STATE OF MAINE  
DEPARTMENT OF TRANSPORTATION  
16 STATE HOUSE STATION  
AUGUSTA, MAINE 04333-0016

February 22, 2023  
Subject: Frank J. Wood Bridge  
Replacement  
State WIN: 022603.00  
Location: **Brunswick & Topsham**  
**Amendment No. 1**

*PIER NO. 2 END ELEVATION*  
Upstream End Shown

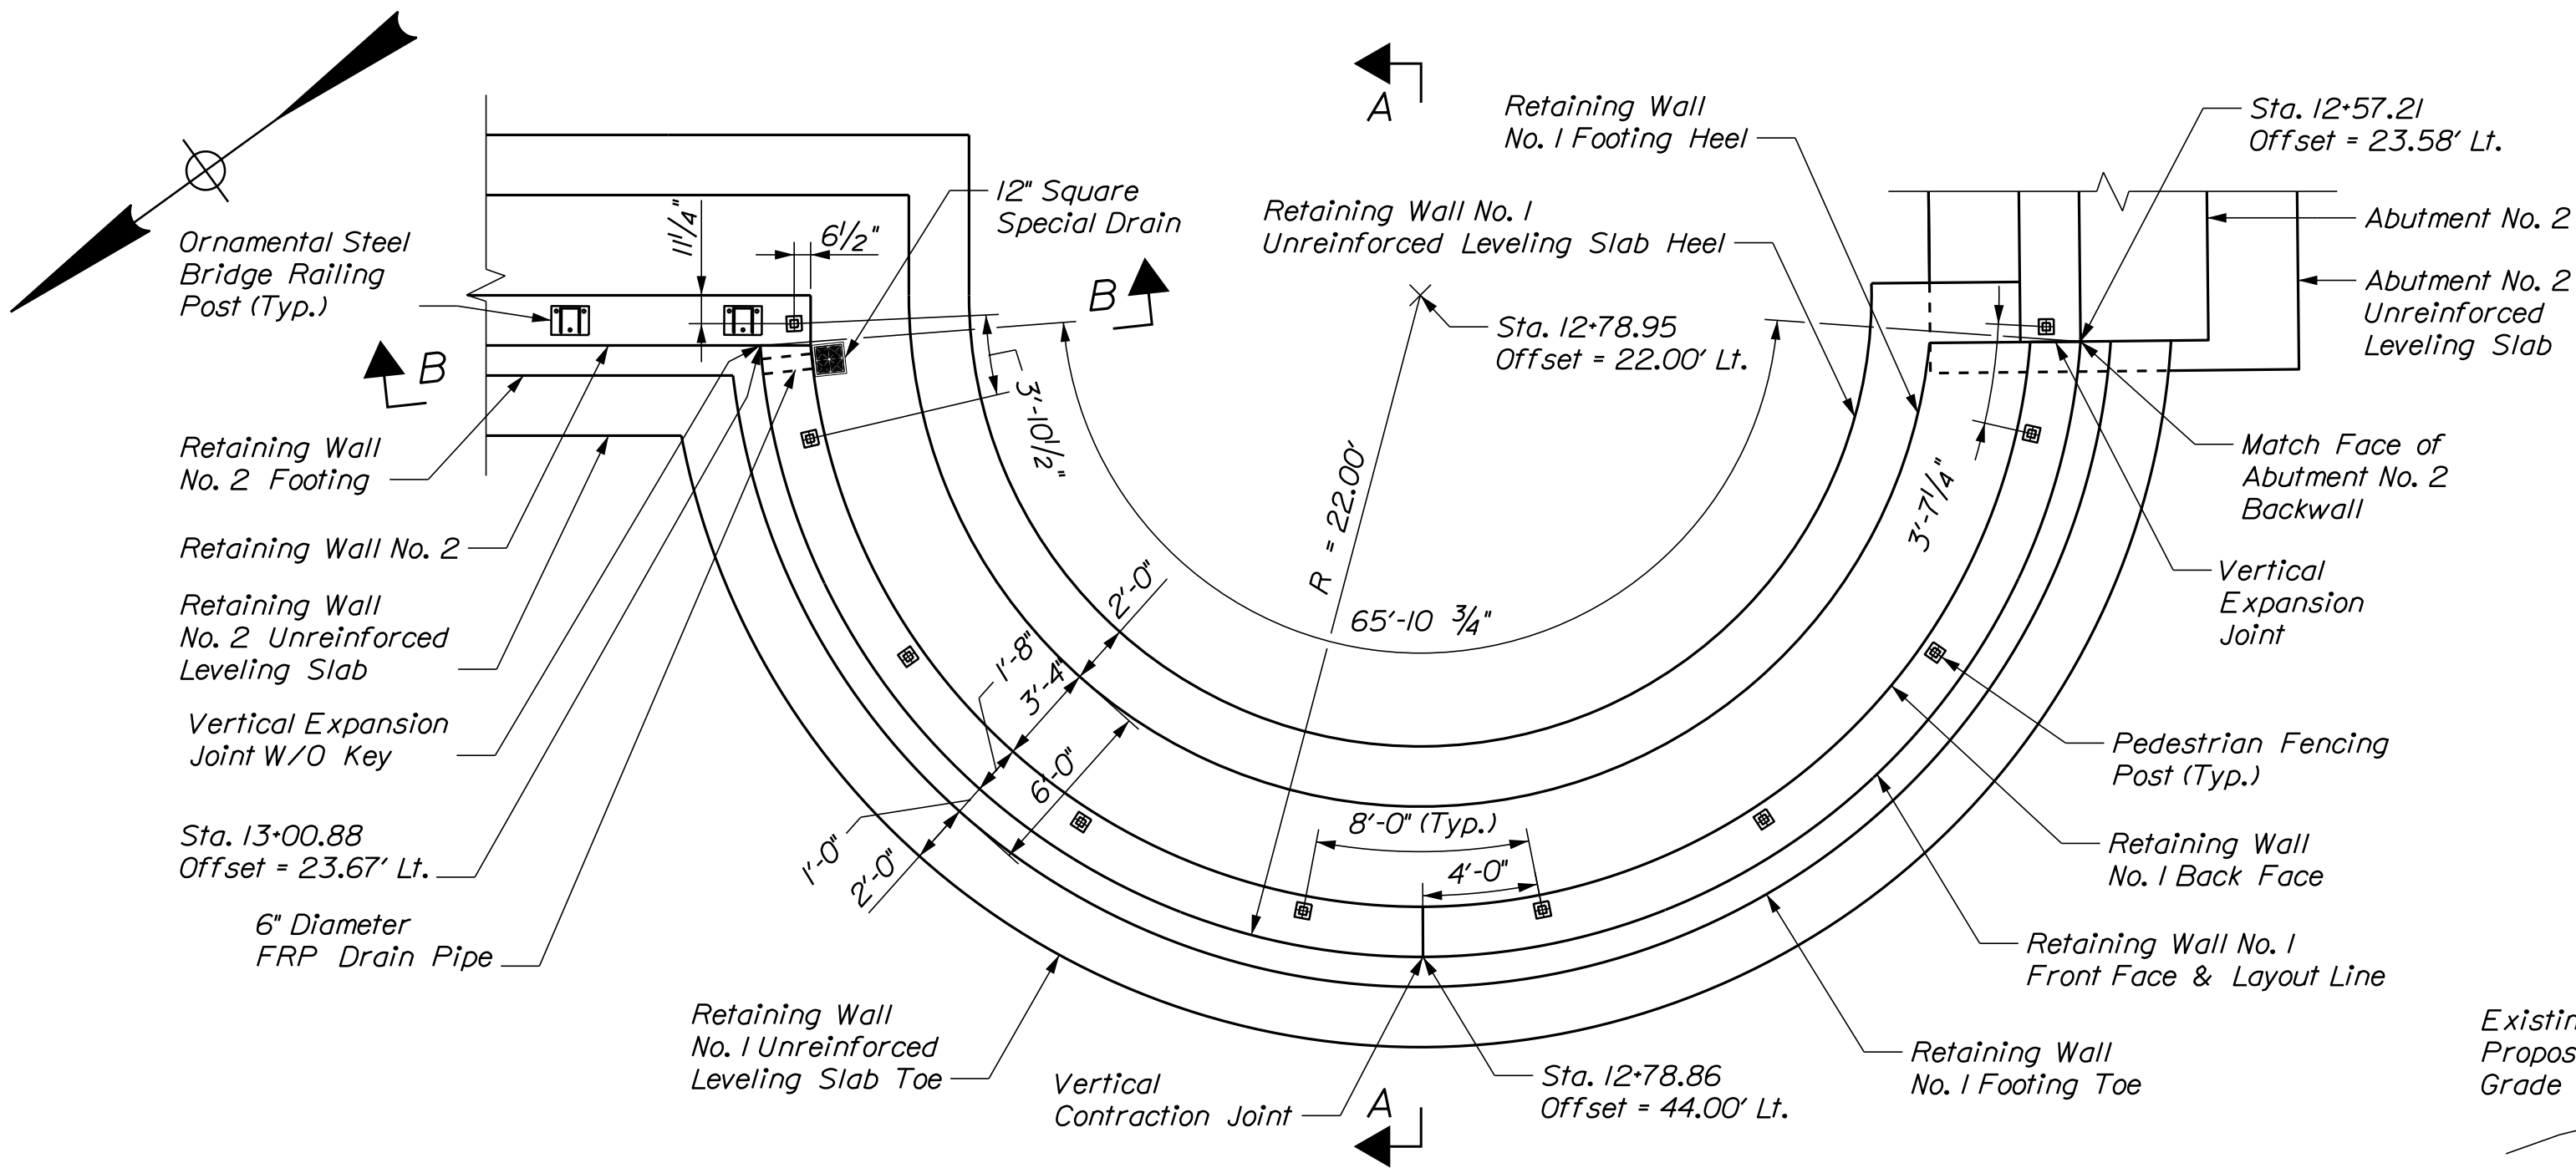
**REMOVE** sheet 87, PIER NO. 2 SHAFT PLAN & ELEVATION, 1 sheet dated 7/21 and **REPLACE** with attached sheet 87A, PIER NO. 2 SHAFT PLAN & ELEVATION, 1 sheet dated 2/16/2023.

**Question:** What is the reason for two different sets of Pier Design Criteria notes on Sheets 84 & 87?

**Response:** See the above changes to the bid documents.

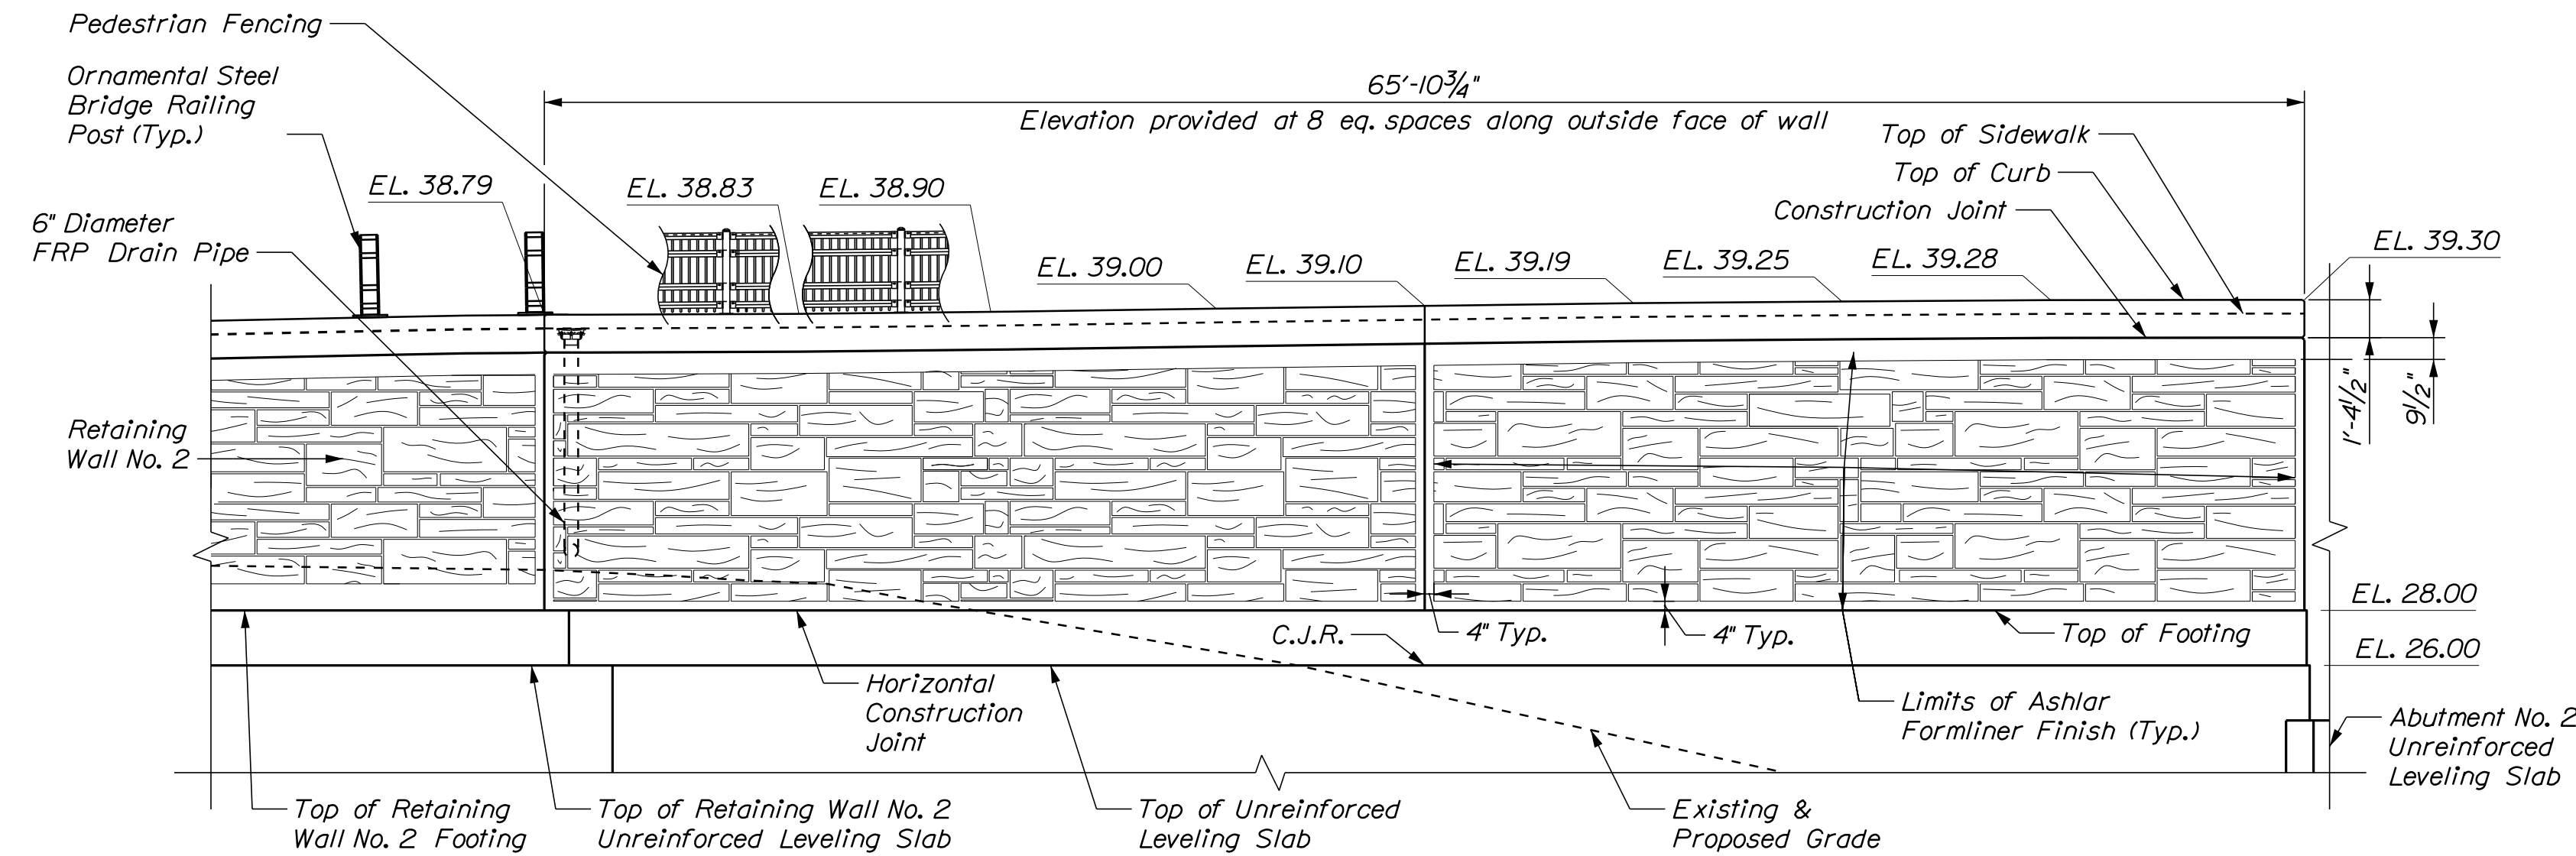
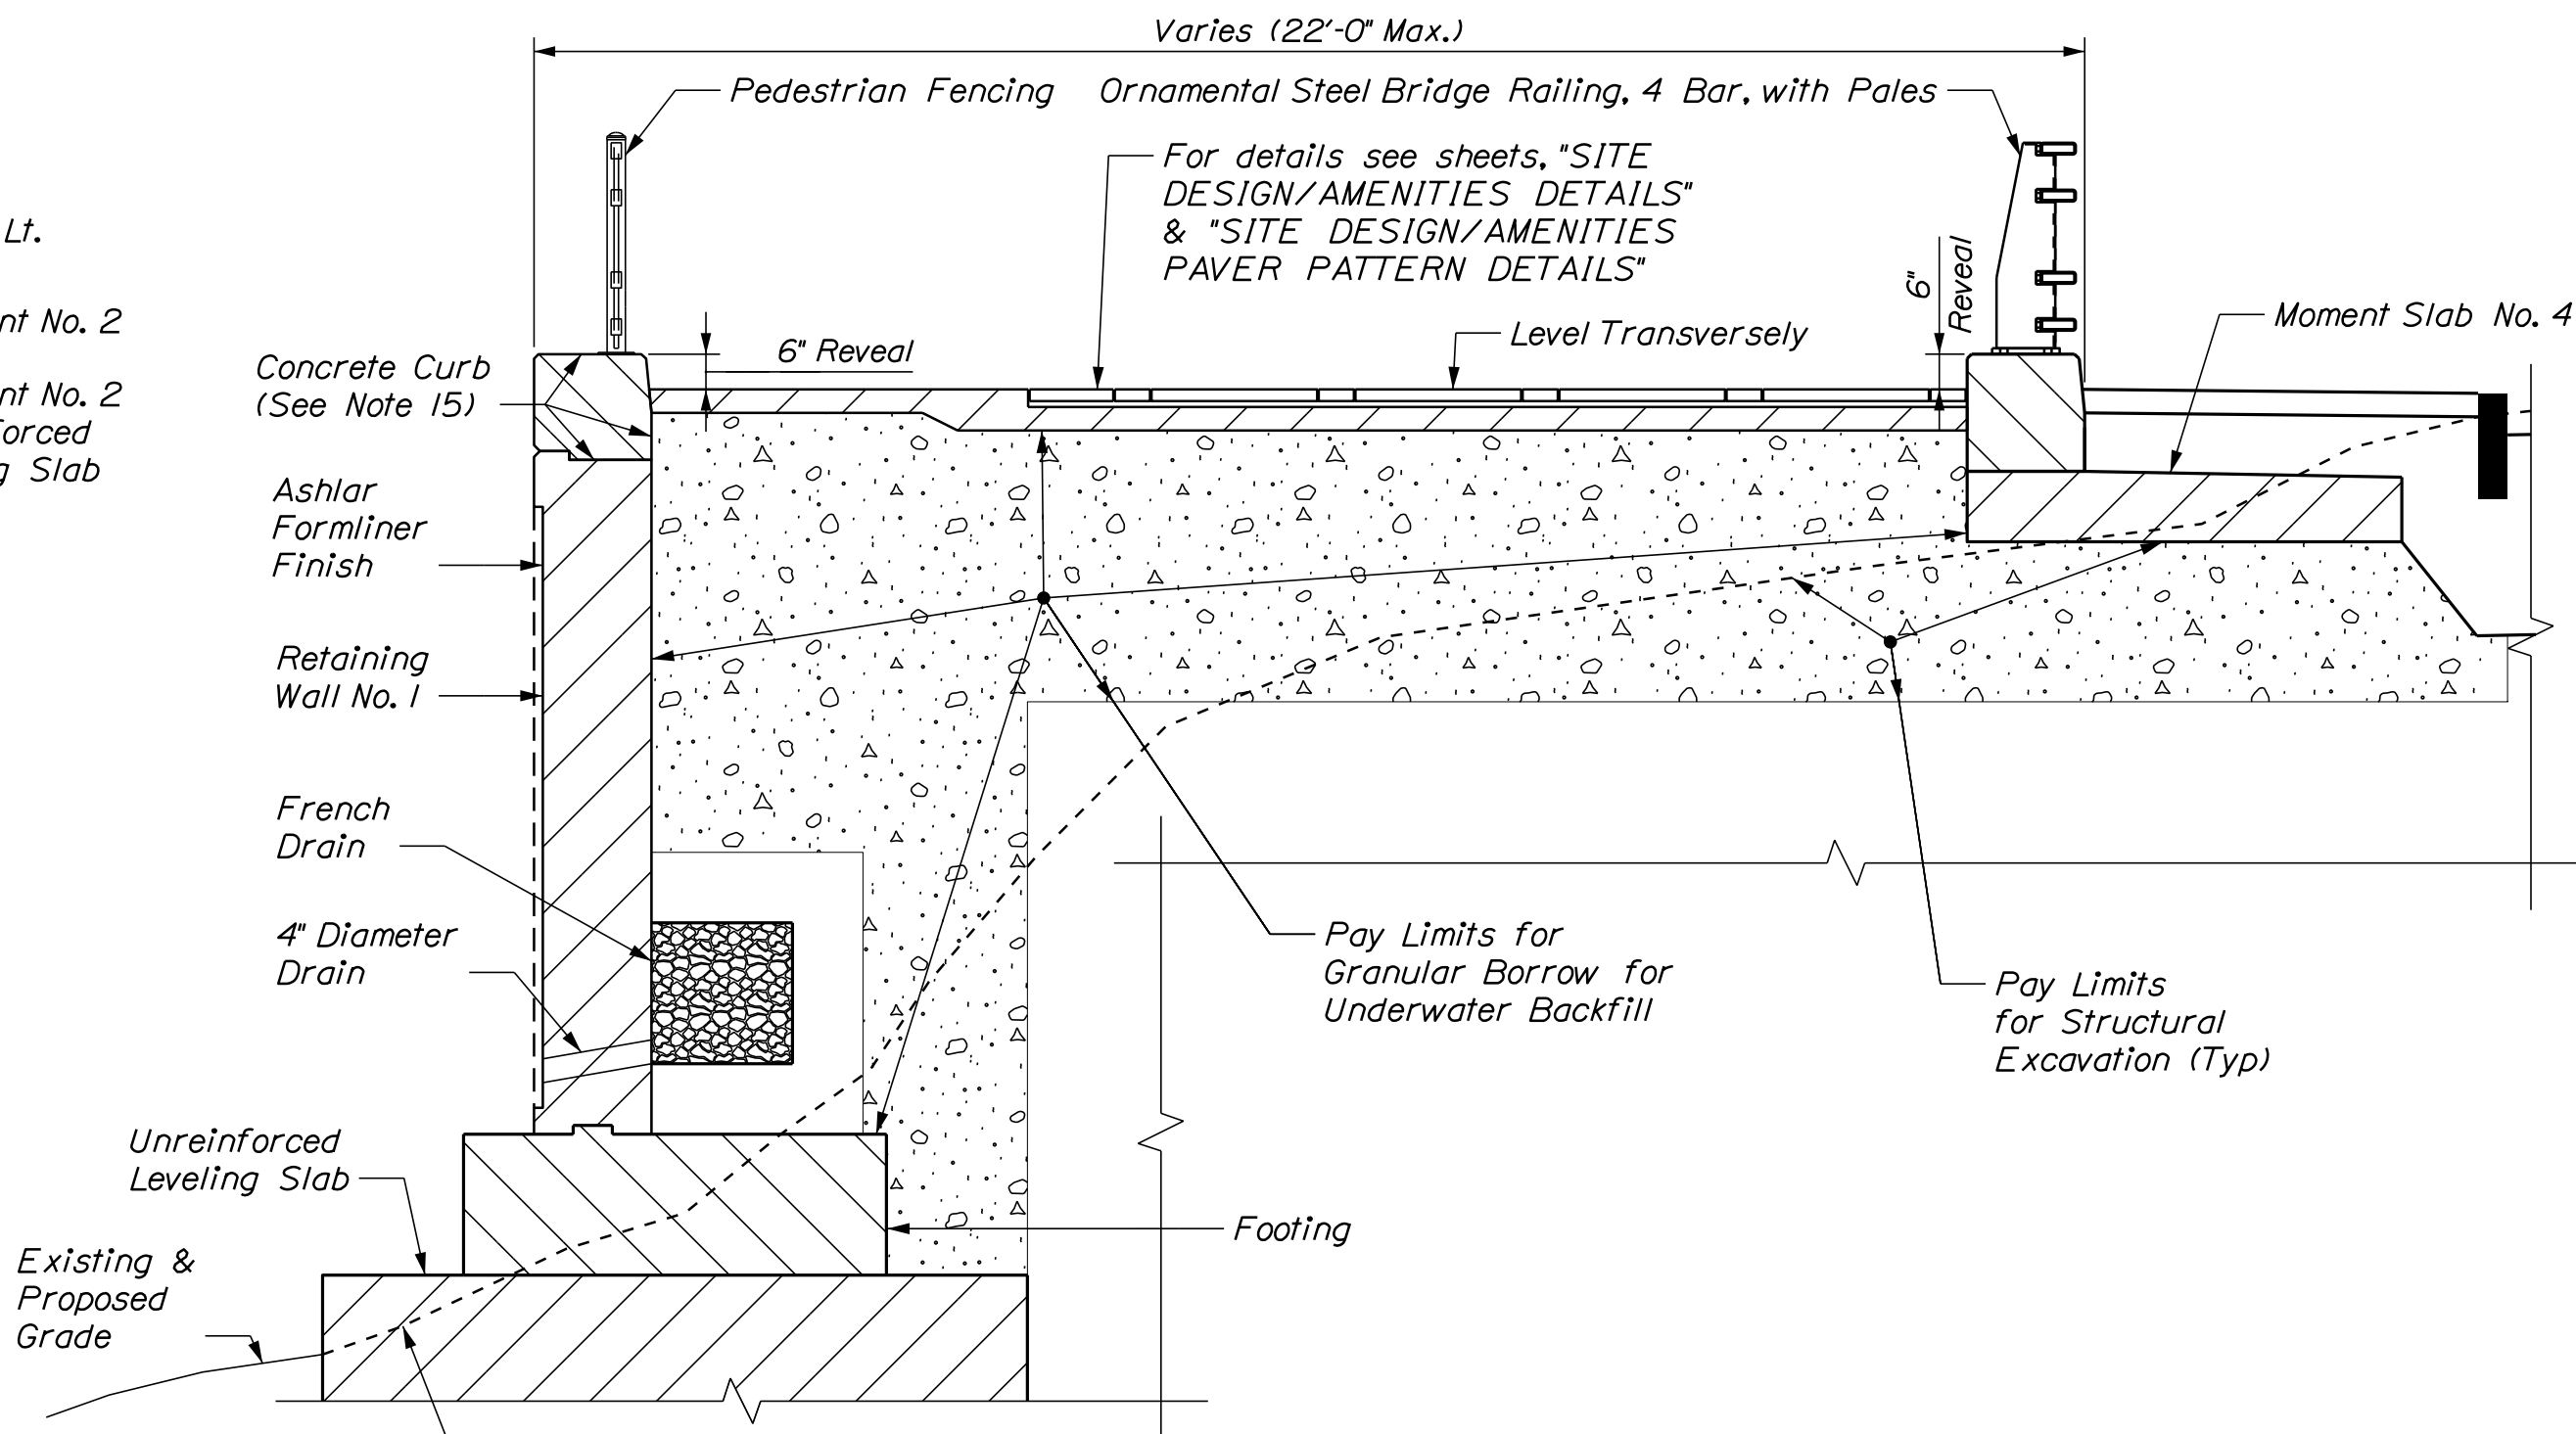
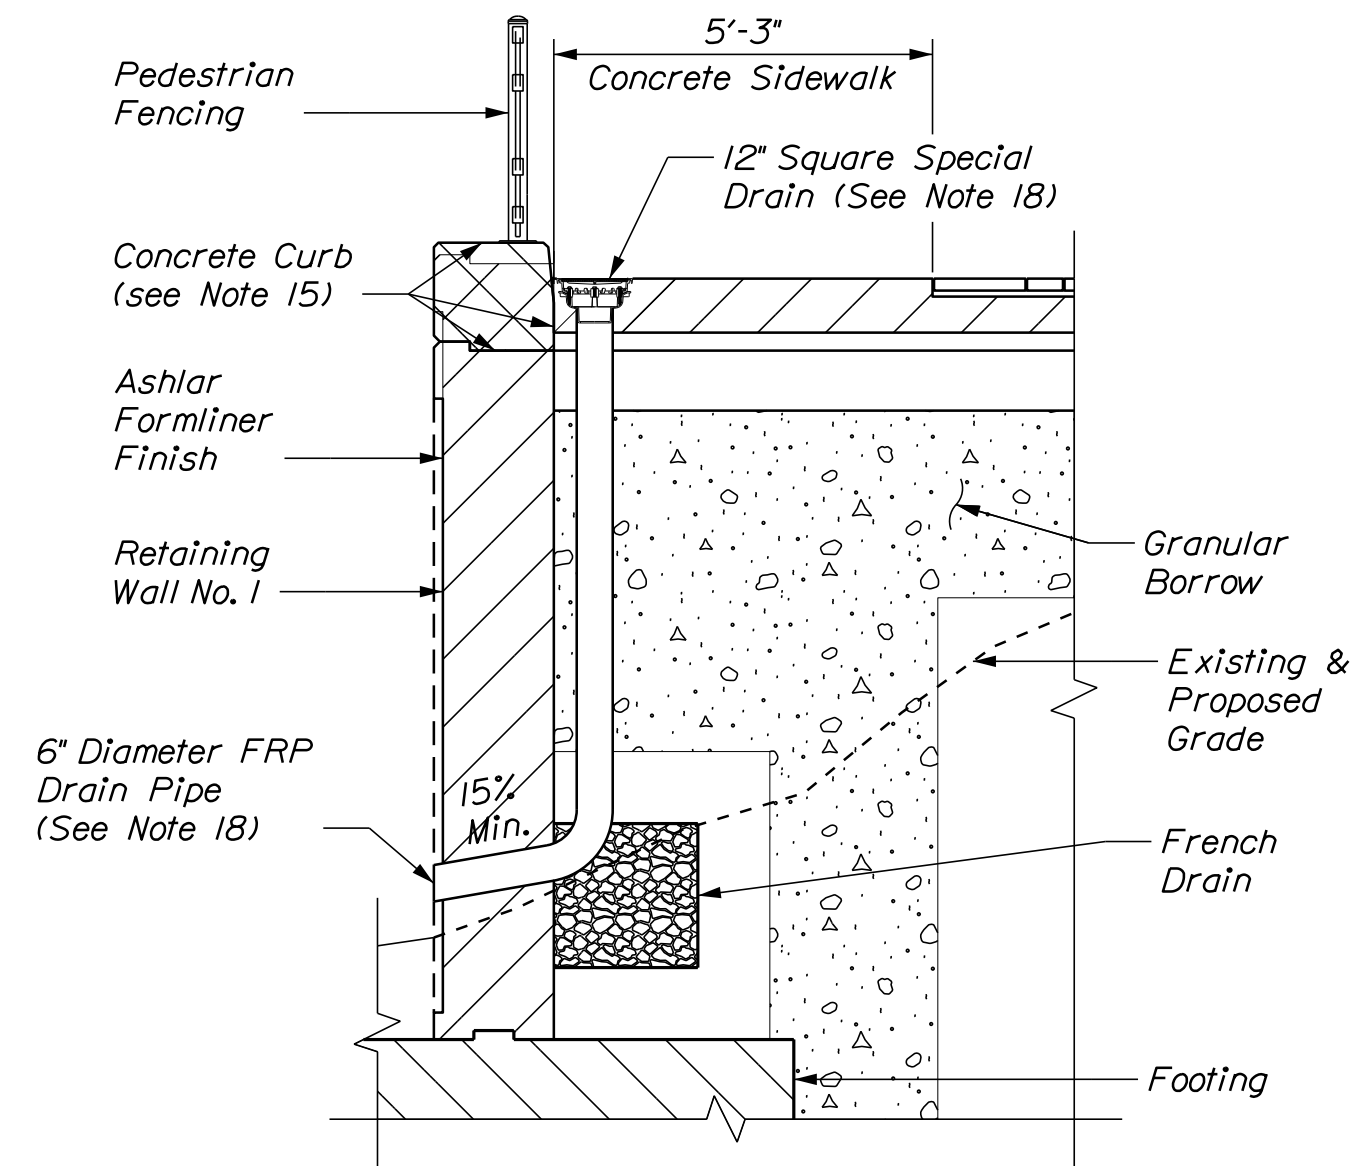
**REMOVE** sheet 94, RETAINING WALL NO. 1 PLAN AND ELEVATION, 1 sheet dated 2/21 and **REPLACE** with attached sheet 94A, RETAINING WALL NO. 1 PLAN AND ELEVATION, 1 sheet dated 2/16/2023.

**Question:** Sheet 94 Retaining Wall Notes 1 and 14 refer to a Retaining Wall No. 4; however, there are no details for a Retaining Wall No. 4. Please confirm that there is no Retaining Wall No. 4.

**Response:** There is no Retaining Wall No. 4 in the contract. See the above changes to the bid documents.
